**Title: QUALITY AUDIT
INCLUDING
Road Safety Audit, Access Audit, Cycle Audit and Walking
Audit.
For;
Barrington SHD, Brennanstown Road, Cabinteely.**

Report reference: 1432R01

VERSION: FINAL (April 2022)

Drawing BRR-WM-ZZ-00-DR-C-P013 – Rev -, Brennanstown Road Junction.

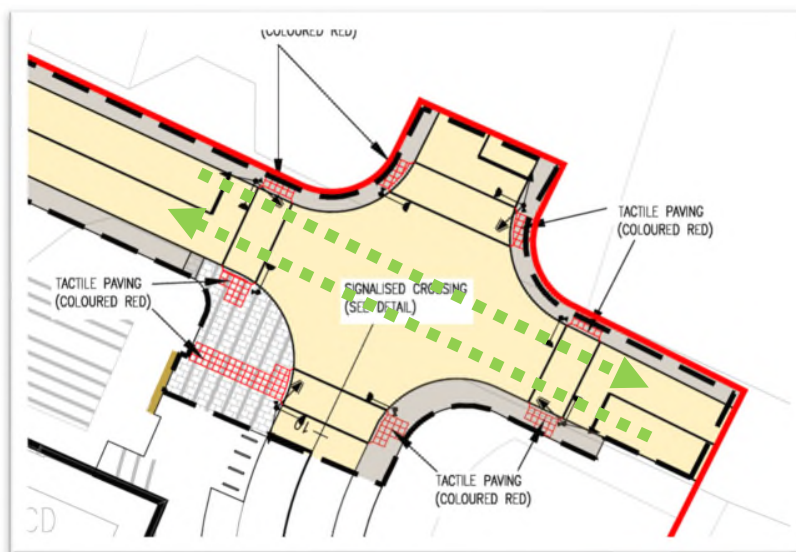
The swept path of a refuse vehicle is shown on the drawings. The junction will have to cater for large heavy goods vehicles during construction and future upgrades etc. albeit on an infrequent basis. There is a risk that such vehicles will not be able to turn at the junction and will mount the footpaths and possibly damage street furniture and put vulnerable road users at risk.

Ensure that the junction can cater for the turning of large goods vehicles.

3.1	Yes	YEs	As shown on drawing BRR-WM-ZZ-00-DR-C-P015 which shows the autotrack analysis of a large good vehicle entering the site, the junction can accommodate the turning of infrequent large goods vehicles to the site. In line with DMURS, the junction has been designed to accommodate pedestrian and cyclist movements and to encourage slow movement of vehicles.	Yes

Drawing BRR-WM-ZZ-00-DR-C-P011 – Rev -, Southern end of access road. Ch 360

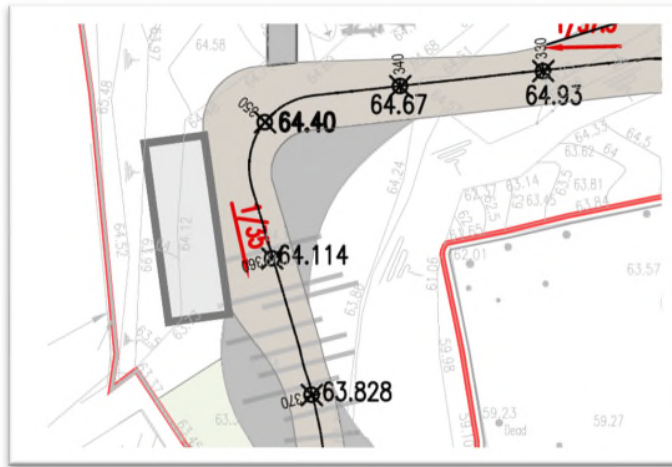
It is unclear if there is sufficient space for vehicles to U-turn at the end of the access road. A lack of space could lead to damage to structures and material damage of vehicles.

It is recommended that a turning space be provided at the end of the route intended for vehicle use.

3.3	Yes	Yes	Refer to drawing BRR-WM-ZZ-00-DR-C-P013 attached which shows the autotrack analysis for a refuse vehicle which can turn at 2 No. locations without any problem.	Yes
